PRIVATE WATER DISTRIBUTION SYSTEM IMPROVEMENTS  
 TO SERVE  
**WATERFRONT 6TH ADDITION**

10250 E. 13TH STREET N.  
 WICHITA, KS 67206  
 THE CITY OF WICHITA, KANSAS  
 GARY JANZEN, P.E. - CITY ENGINEER  
 PROJECT NO.  
 2049PPW (183021)

**AS BUILTS**

Contractor: Wilks Underground  
 Inspector: Matt Perez  
 Date: 8-1-2017

PLAN FIRE LINE 1  
 PROFILE FIRE LINE 1

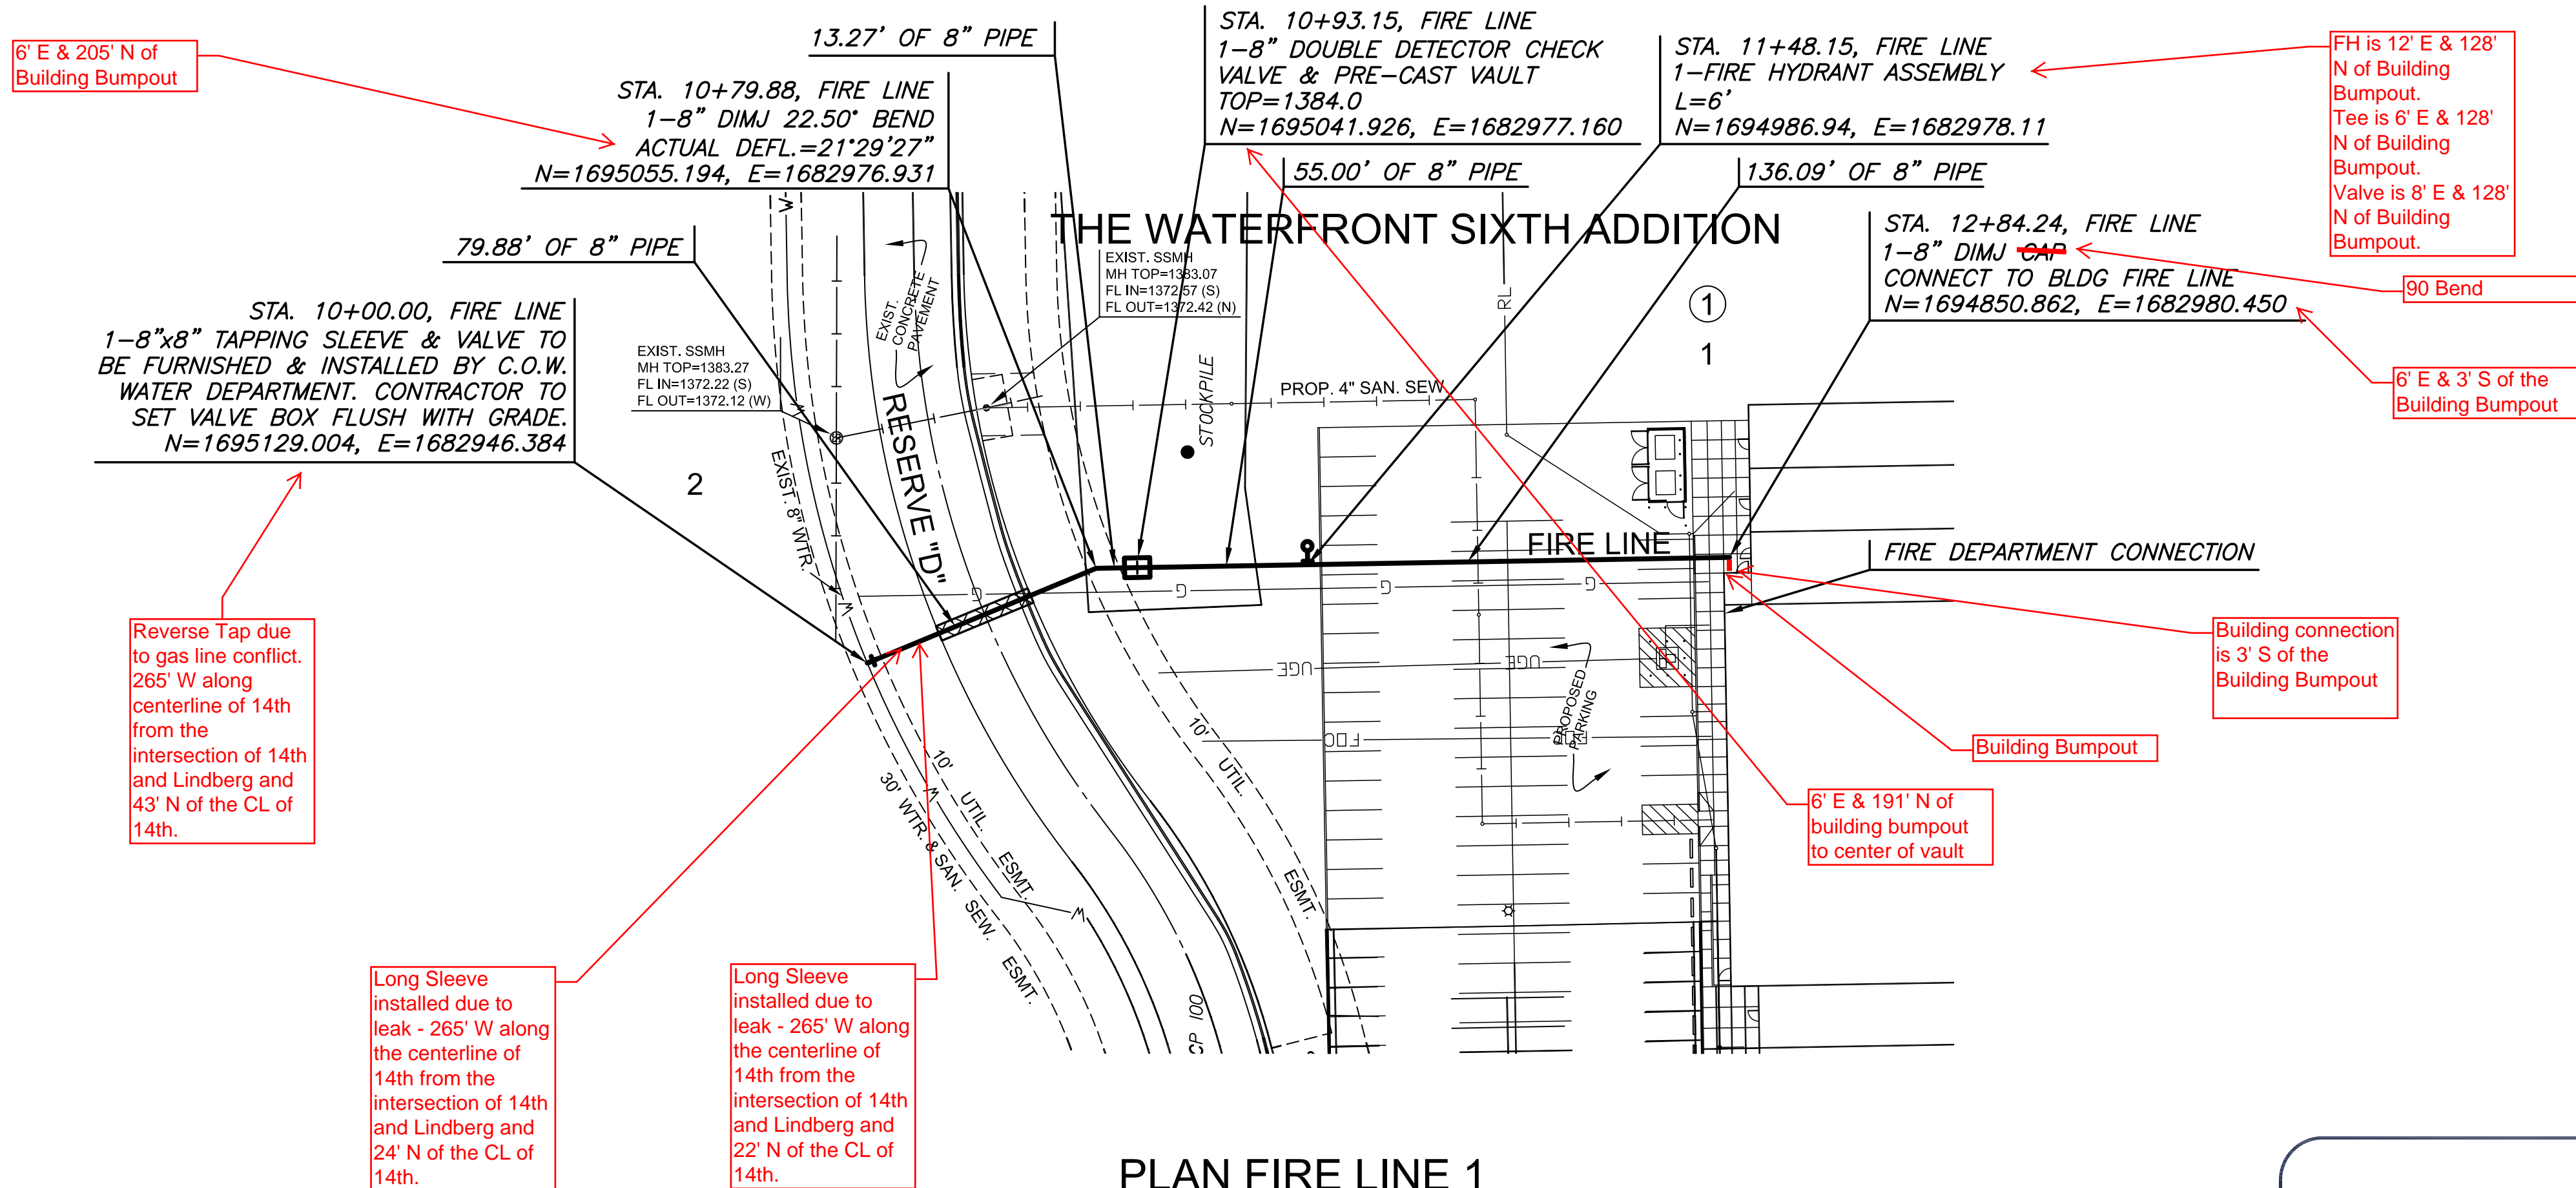
Reverse Tap due to gas line conflict. 265' W along centerline of 14th from the intersection of 14th and Lindberg and 43' N of the CL of 14th.

Long Sleeve installed due to leak - 265' W along the centerline of 14th from the intersection of 14th and Lindberg and 24' N of the CL of 14th.

Long Sleeve installed due to leak - 265' W along the centerline of 14th from the intersection of 14th and Lindberg and 22' N of the CL of 14th.

Reverse Tap  
 3 LF DI CL  
 4 LF DI CL Vert.
